## FINAL DESIGN REPORT

FOREST HOME DRIVE  
OVER  
FALL CREEK

B.I.N. 3047450

April 2010

**FIGURE 1**

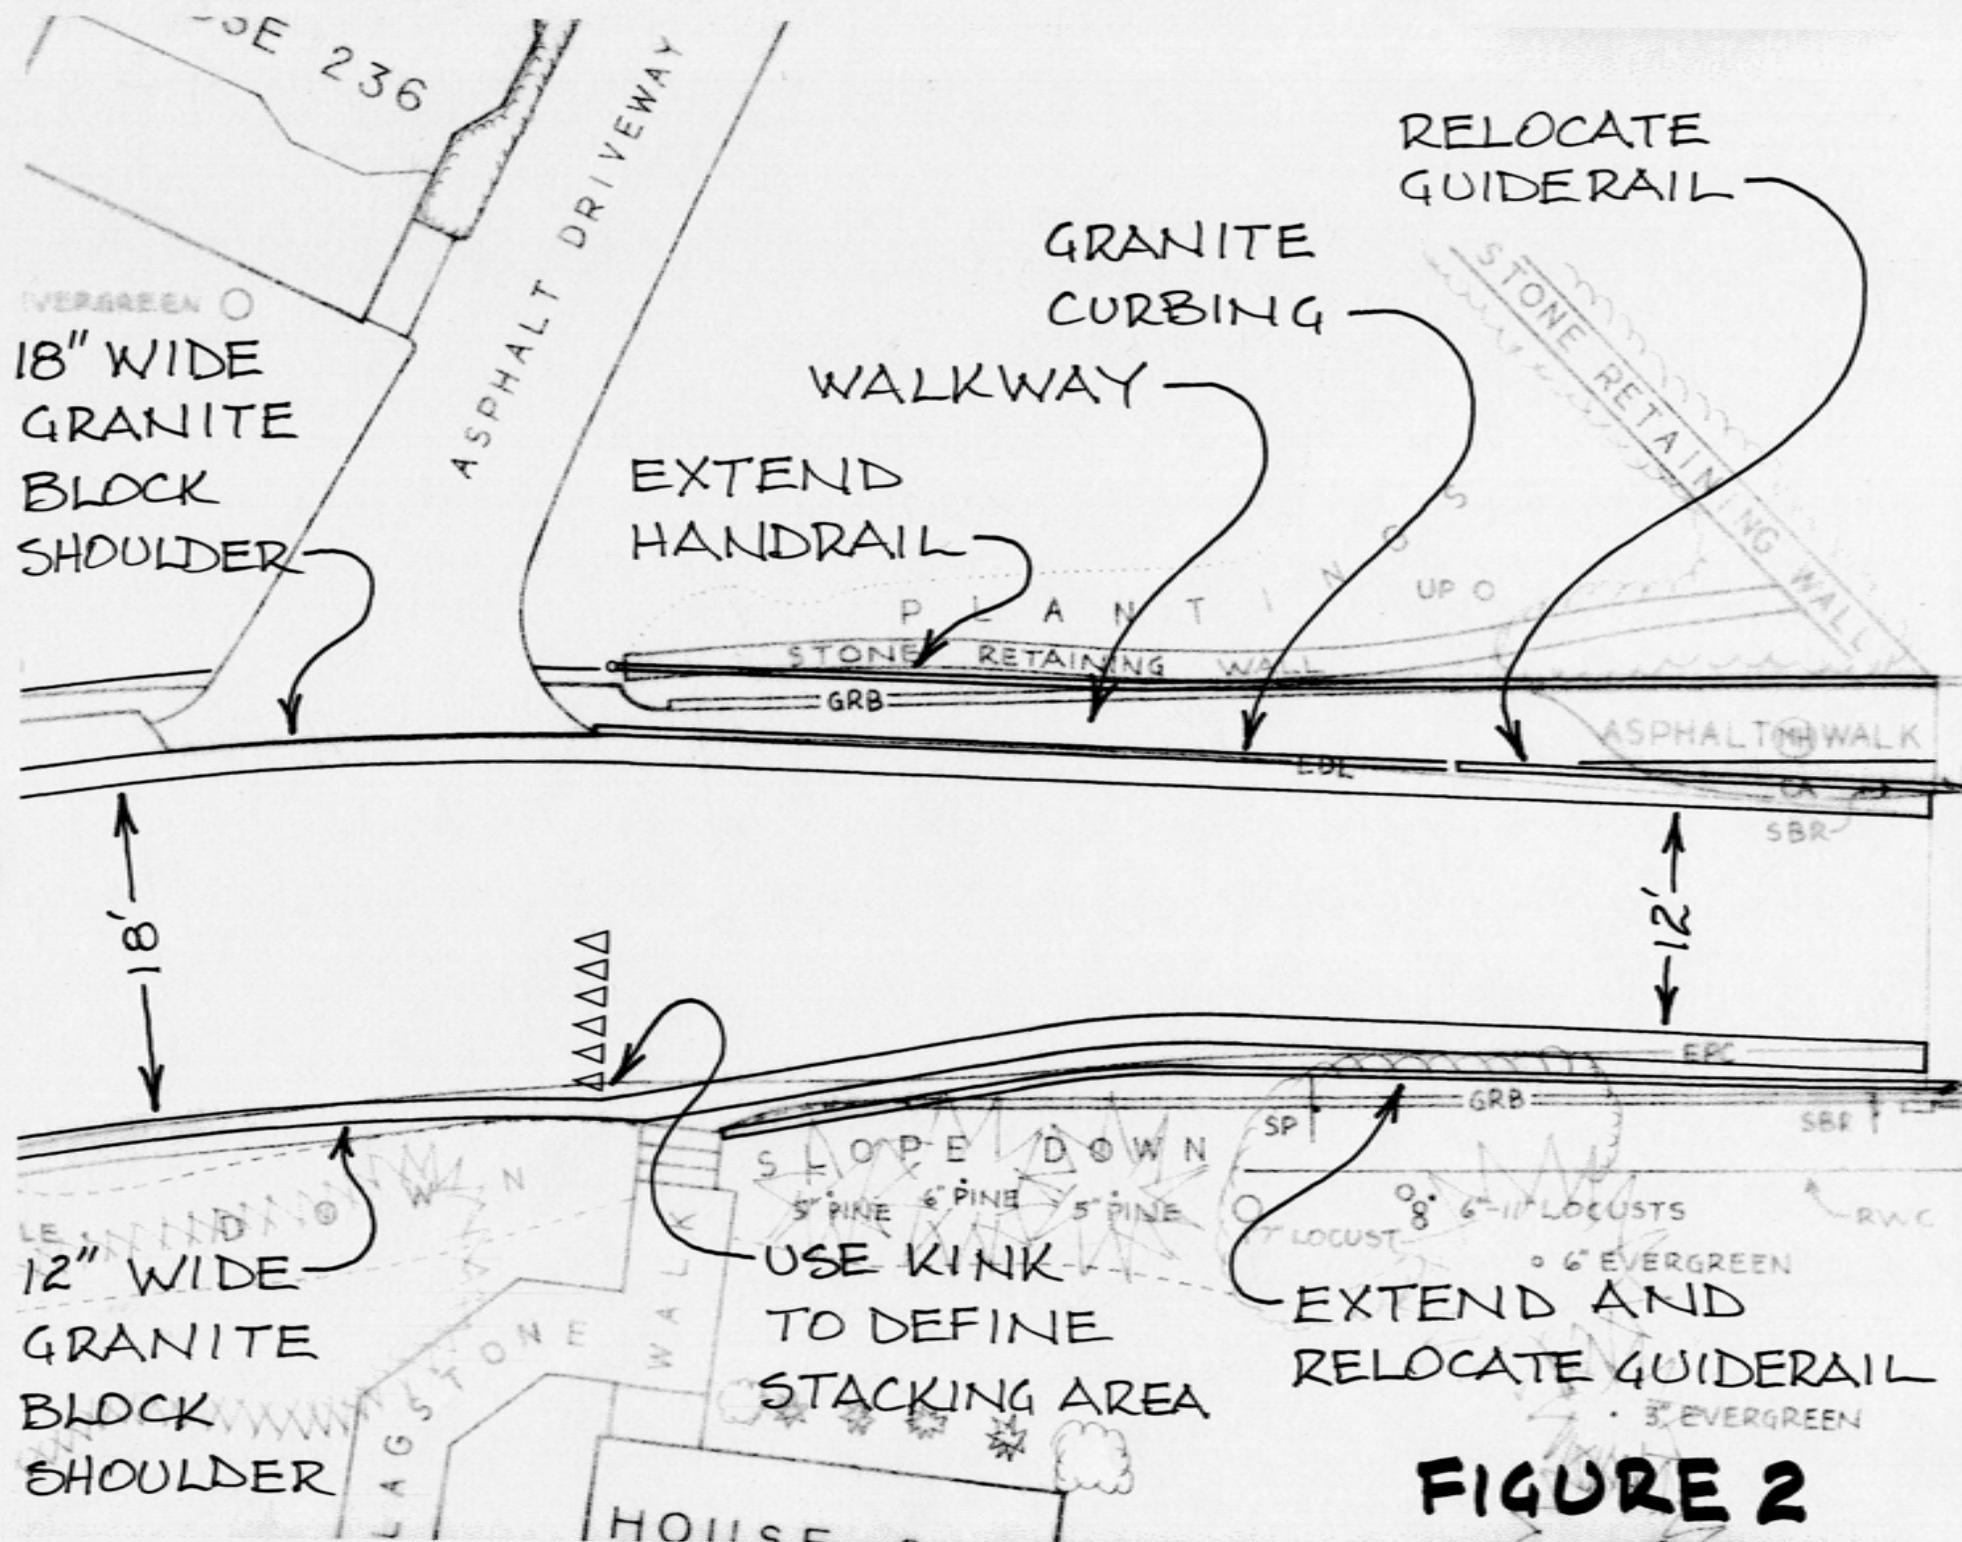
**Figure 1** Shows modifications as specified in the Forest Home Traffic Calming Plan. Features specific to the approach include:

**FIGURE 2**

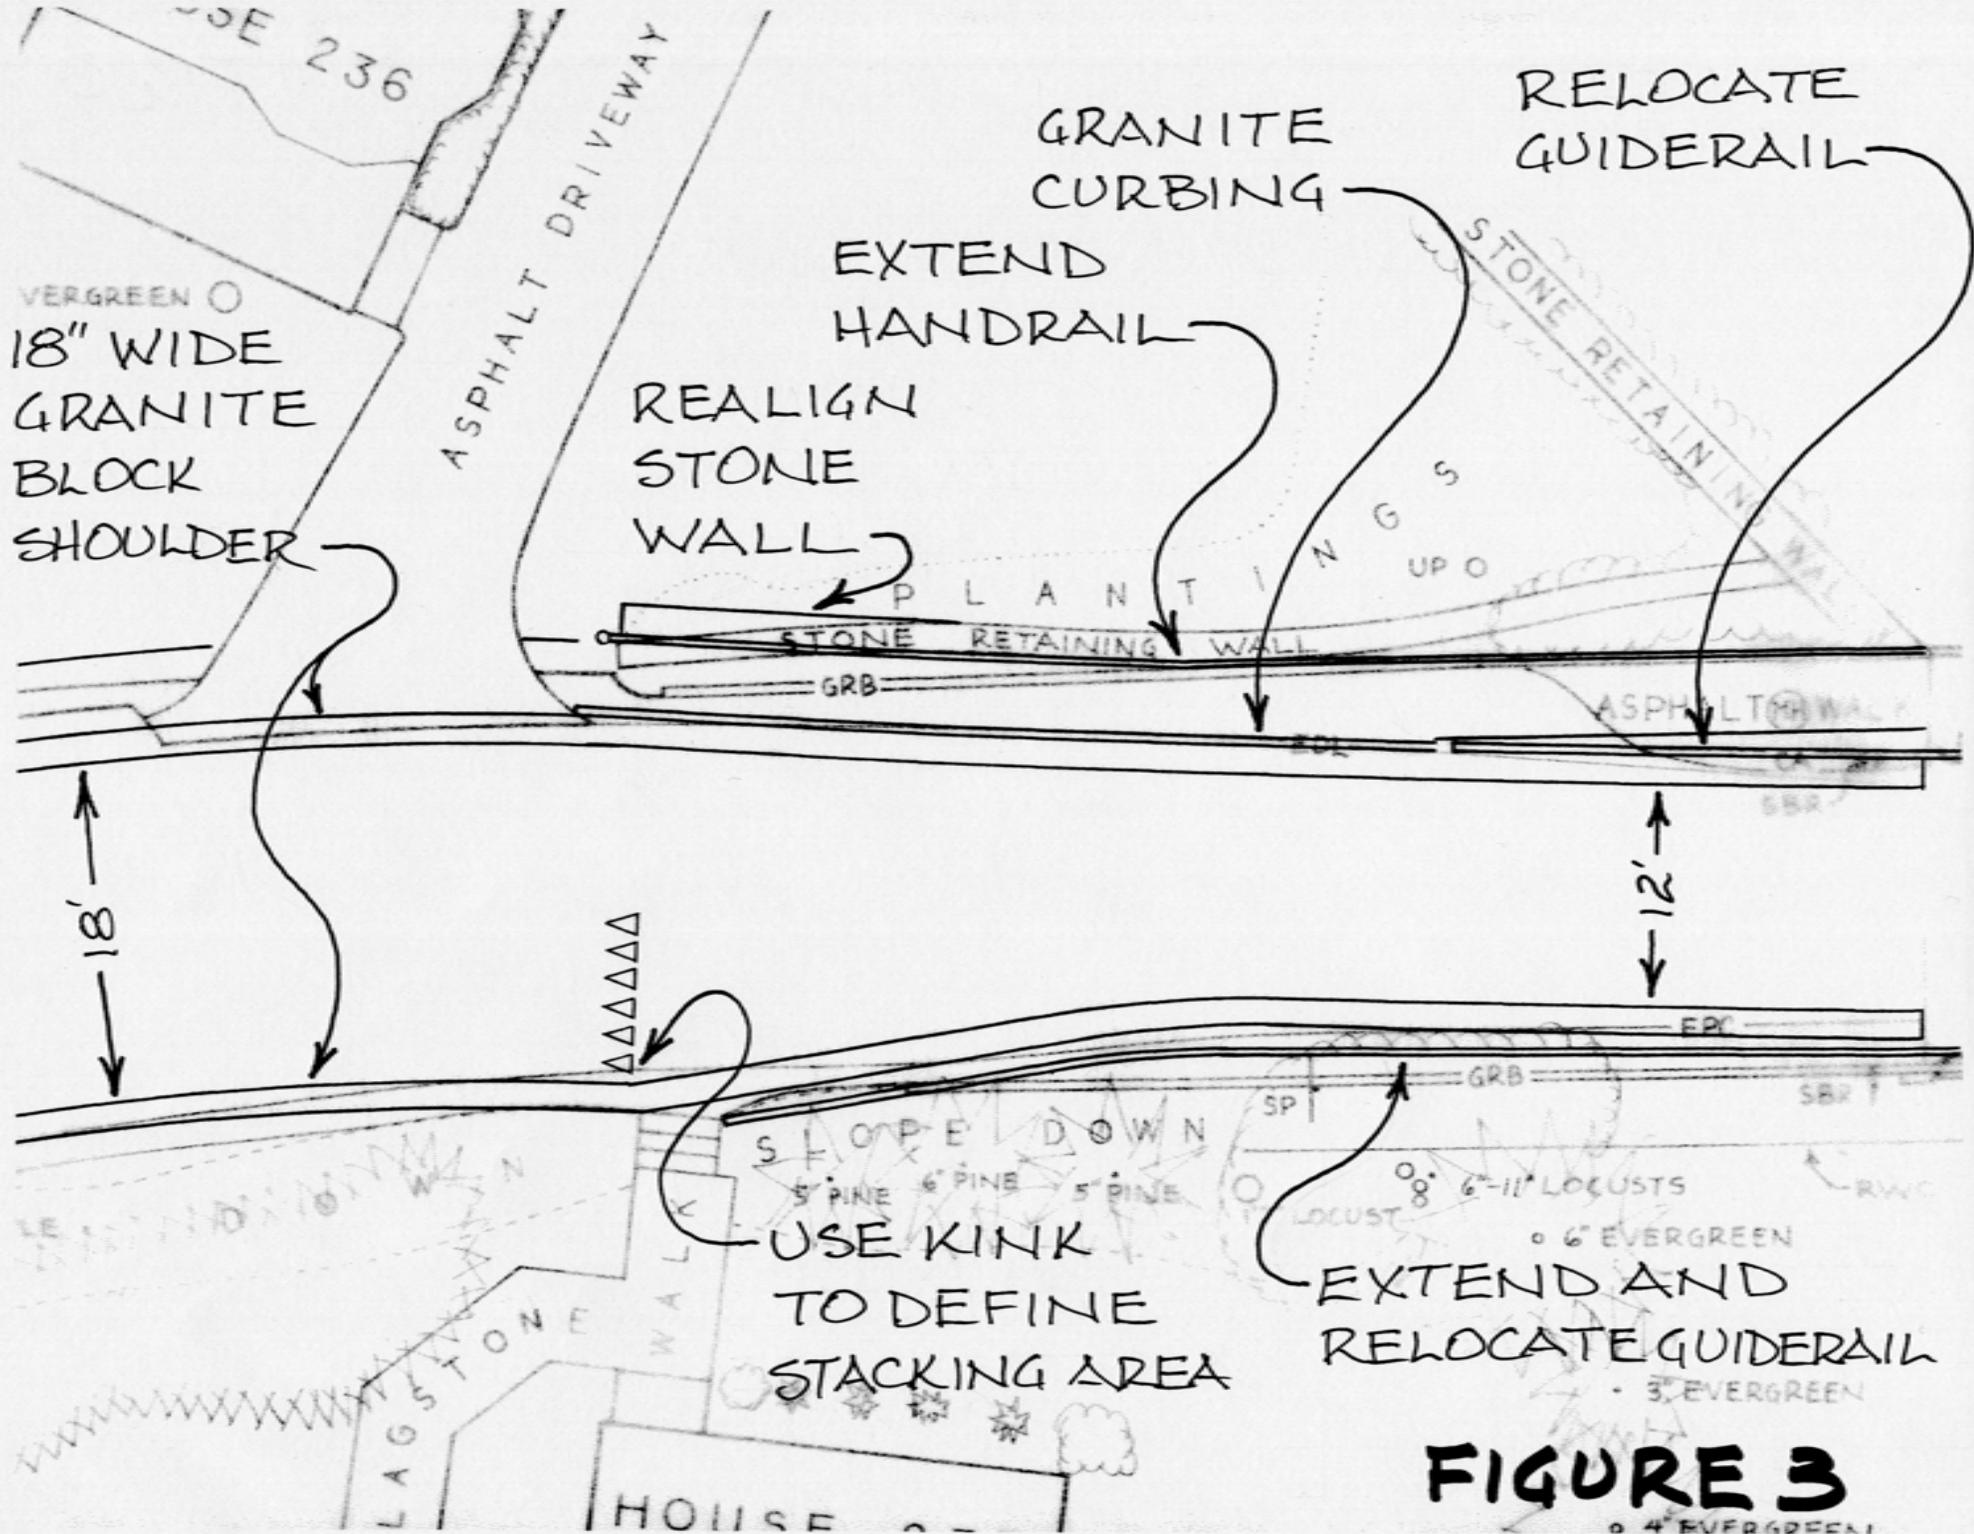
**Figure 2** As specified in the Forest Home Traffic Calming Plan

**FIGURE 3**

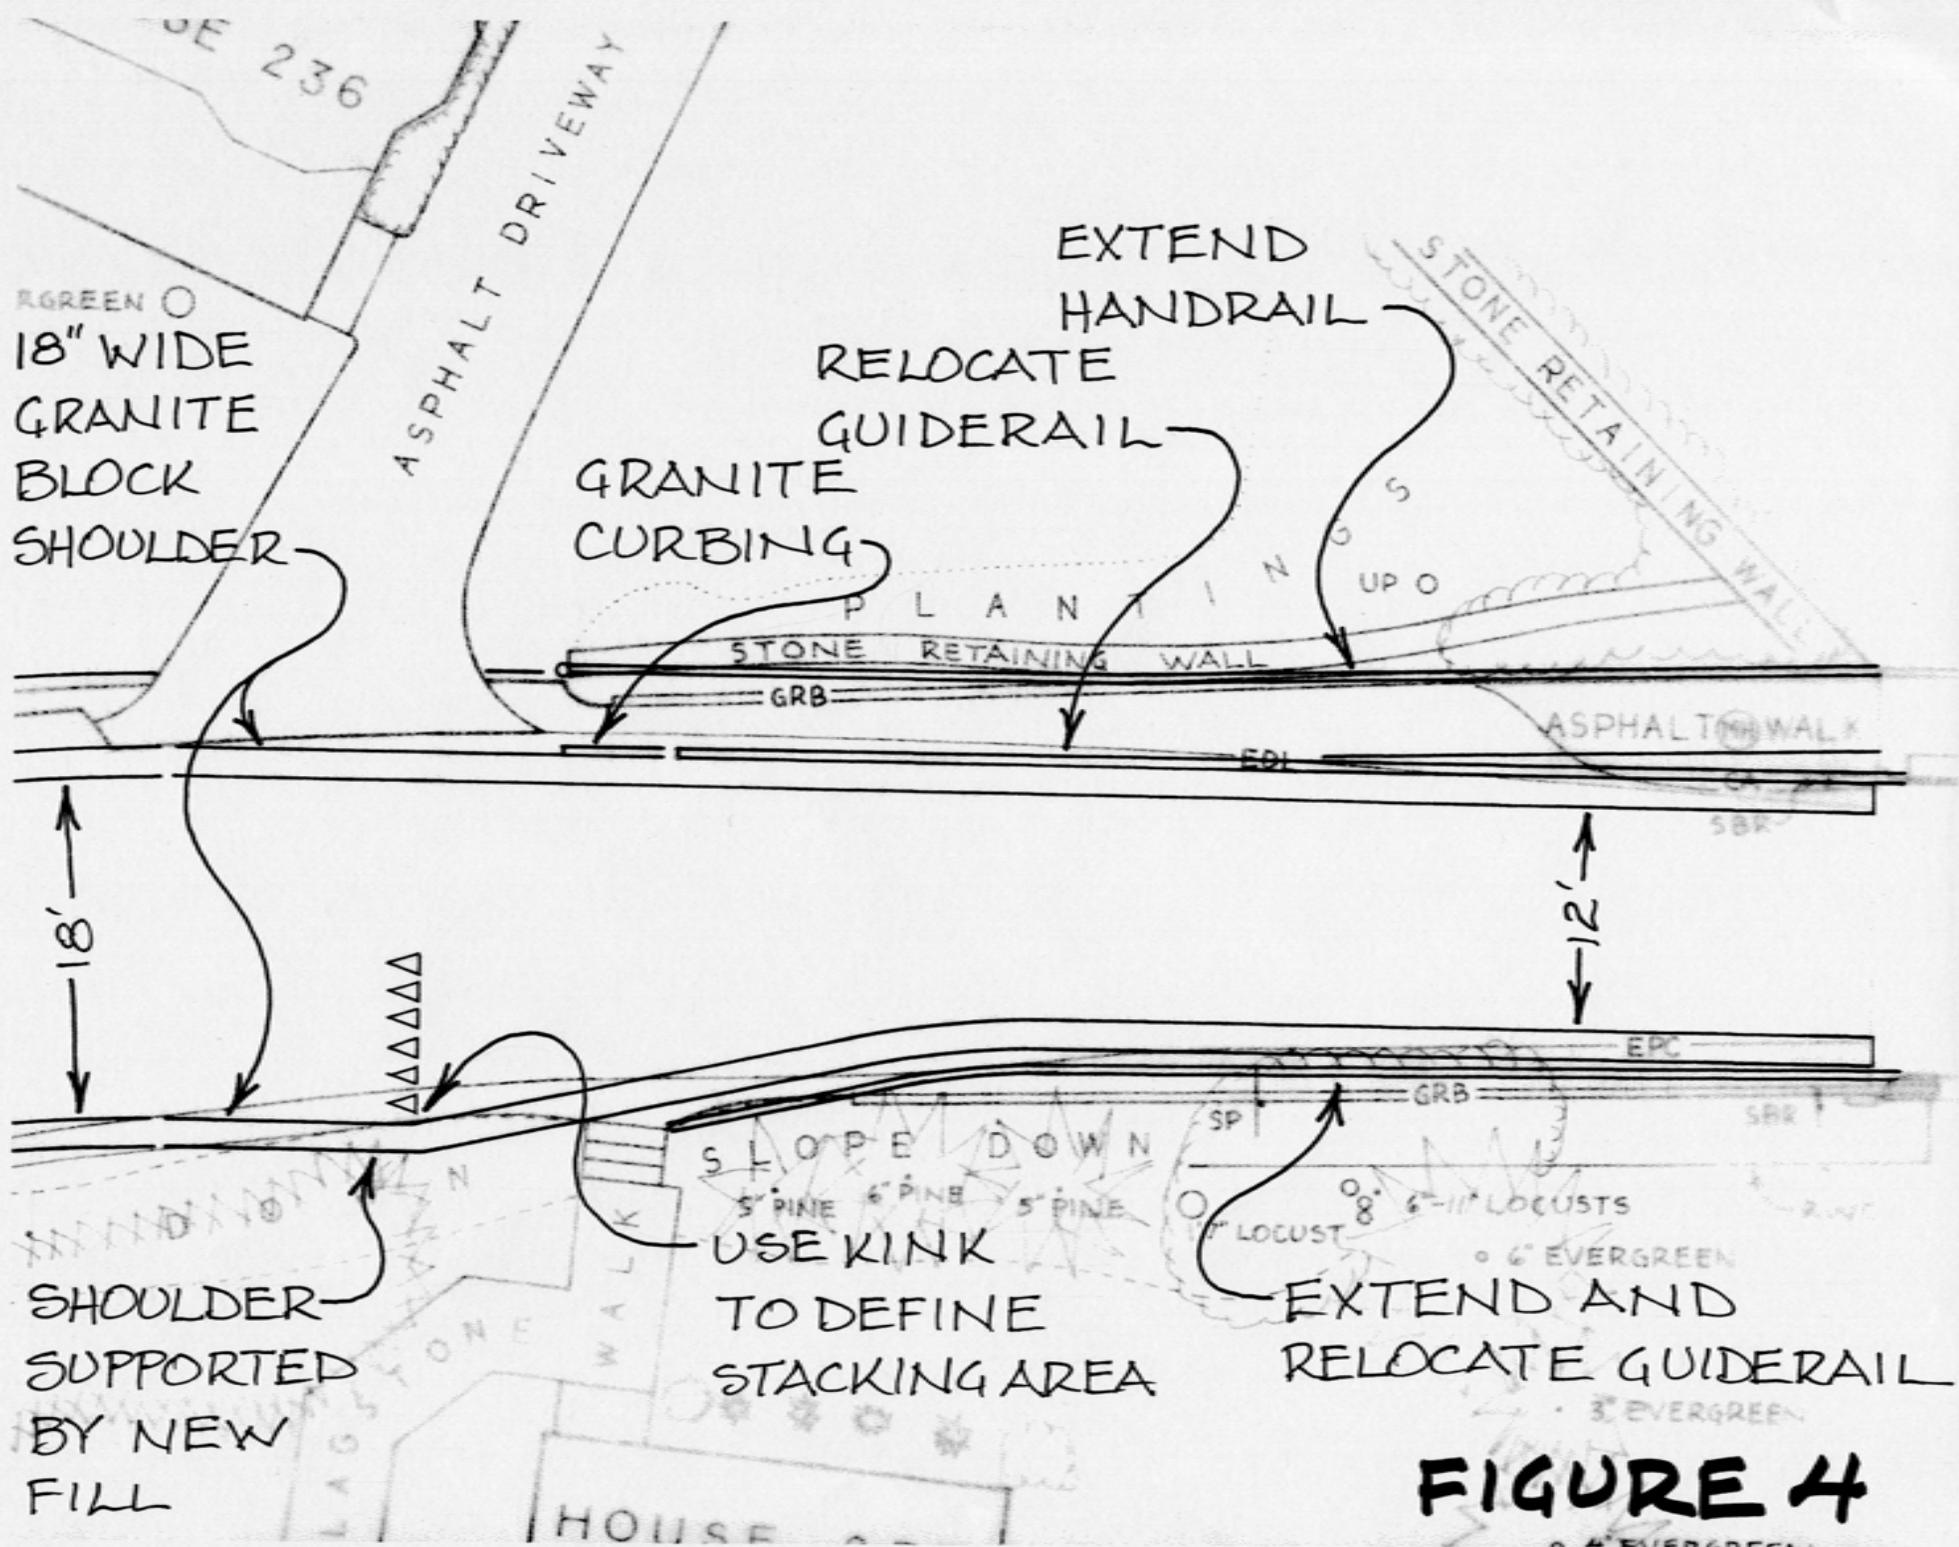
**Figure 3** Minor intrusion on property to north (Shipe, 236)

- Granite curb on north side of road runs from bridge to Shipe's driveway (236).
- Guiderail is located directly above curb, and can extend further out from the bridge without impacting the width of the walkway (60 ft shown in Figure 3).
